U.S. DEPARTMENT OF
ENERGY

Subject: Transmittal of the Part B Permit Application for Renewal of the Los Alamos National Laboratory Hazardous Waste Facility Permit, EPA ID #NM0890010515

Figure 32 TA-63 Transuranic Waste Facility Subsurface Vapor Monitoring Network

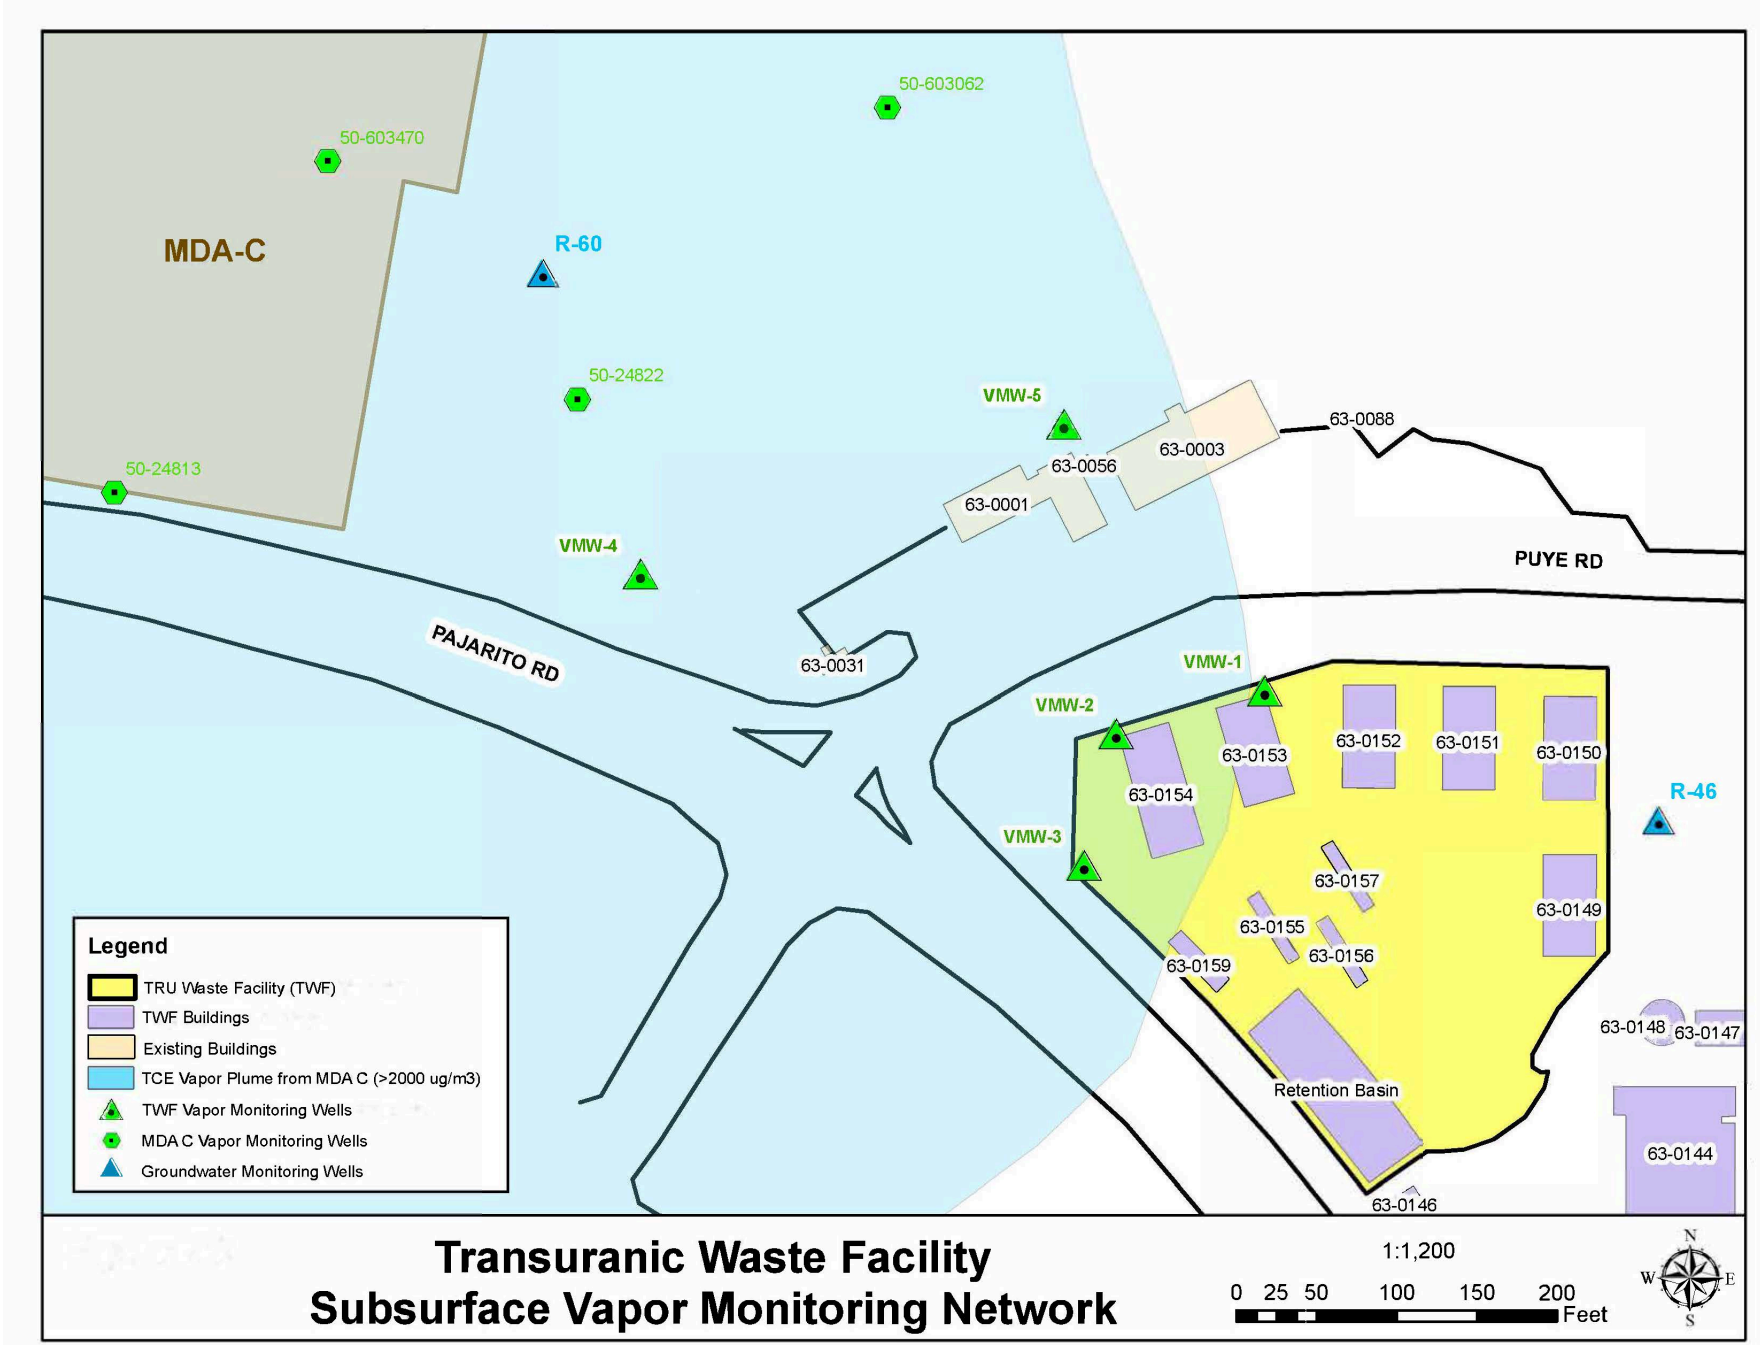
Figure 32 TA-63 Transuranic Waste Facility Subsurface Vapor Monitoring Network	Figure 56	Propose to renumber Figure 56 in the current 2010 Permit to new Figure 32 (TA-63 Transuranic Waste Facility Subsurface Vapor Monitoring Network).	The Permittees propose to rearrange and renumber figures to align with proposed changes and reduce redundancy within the attachment.
